Bob and Sue Nalewajk  
350 Little Harbor Rd  
Portsmouth, NH 03801

September 18, 2019

Re: Conditional Use Permit Amendment  
Tax Map 202, Lot 16  
350 Little Harbor Road  
Portsmouth, NH. 03801

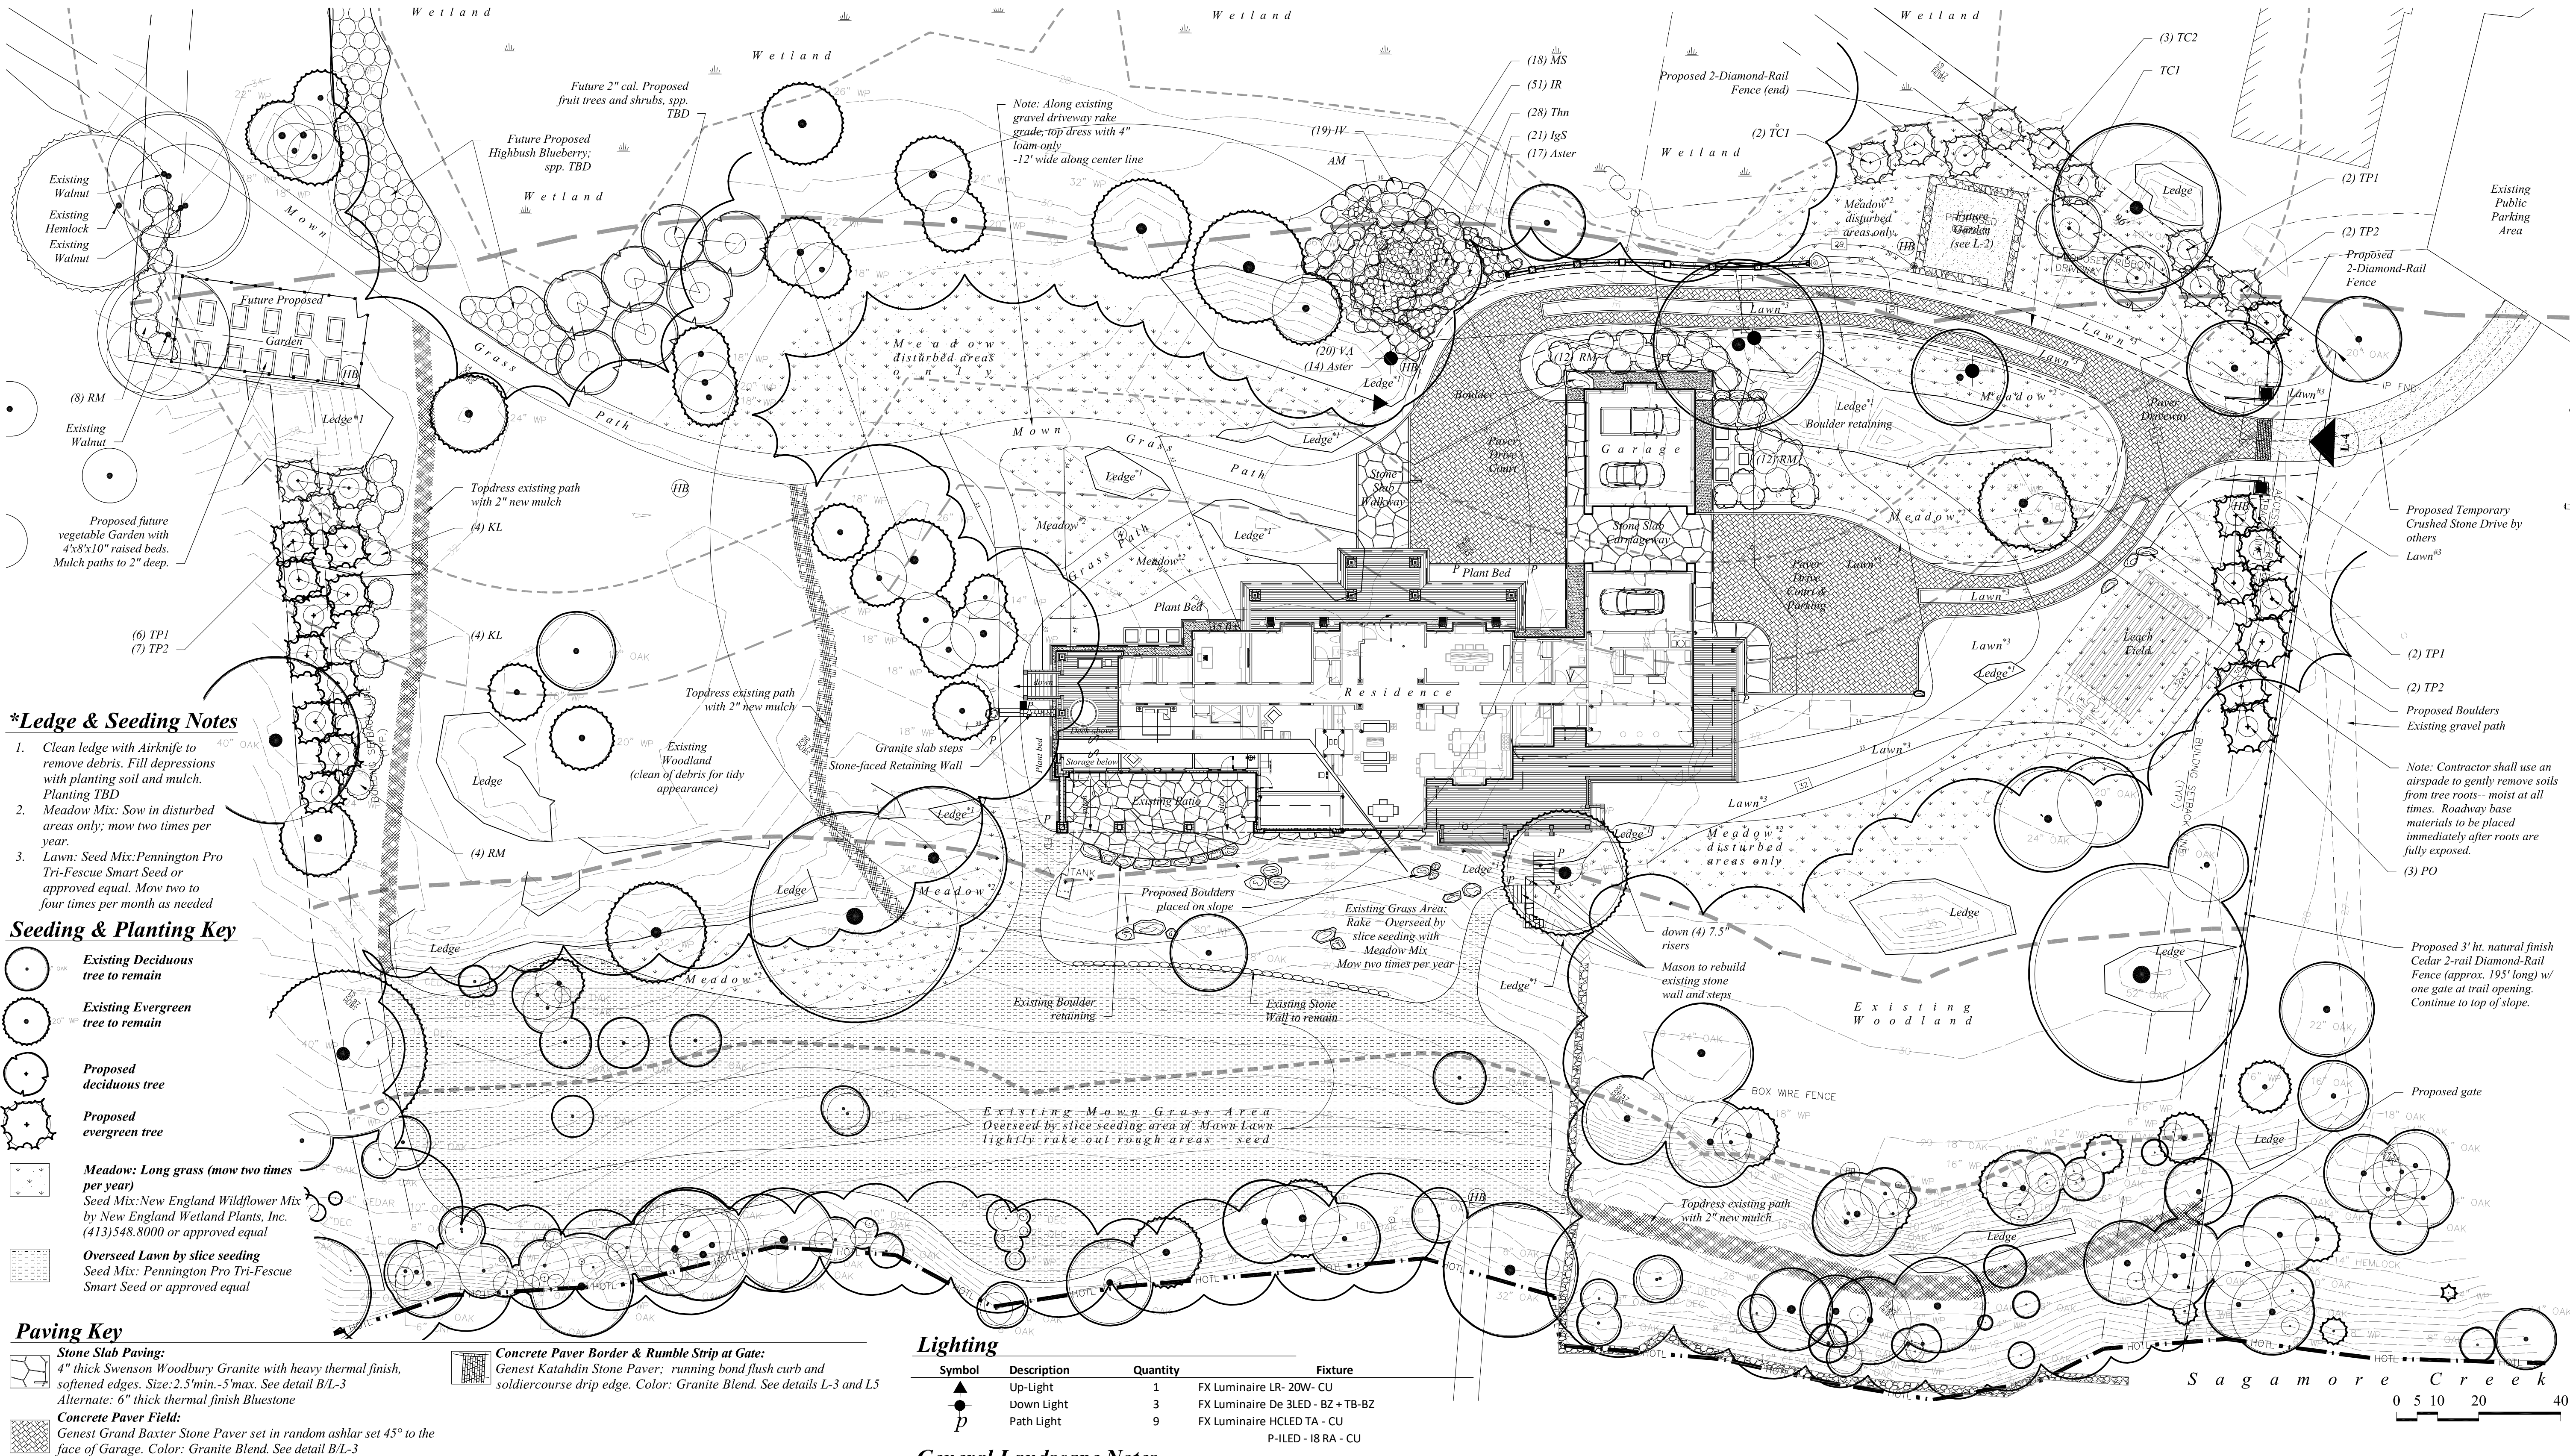
The installation of the permeable paver for the driveway has been completed without cutting out the ribbon. However, we would prefer to eliminate these ribbon cut-outs that were proposed in the CUP, for aesthetic reasons. These cutouts were to be planted with grass and are indicated as "lawn" inside the paver driveway on the northeast entry to the property. We like the look of the pavers as they are now installed and want to eliminate the lawn strips. Approximately 590 square feet of pavers would remain in the driveway, added to the 6444 square feet of driveway permeable pavers that were already approved. A landscaping plan and three pictures of the driveway are attached for your review.

Our engineer has explained to us that a continuous pervious paver surface, engineered to effectively absorb and infiltrate water, would be more permeable than a paver surface broken up by grass, as the grass requires an organic component, specifically soils that consist of fine grained mineral material which do not percolate stormwater as fast as a paver surface. This situation improves the permeability of the driveway, an environmental benefit to leave the driveway as is currently constructed.

While we are most concerned about the aesthetics of this request, in the long run, were we to keep the grass strip, it would add to the overall maintenance of the adjacent paver surface, having to remove organics from the joint spaces between the pavers. Additionally, these strips would require snow blowing (not plowing) in the winter for snow removal so that the organic material is not scraped away. One of our overall goals in this project has

been to keep maintenance of the paver product as simple as possible, so they function as intended into the future. Therefore, we would prefer to eliminate the ribbon cutout.
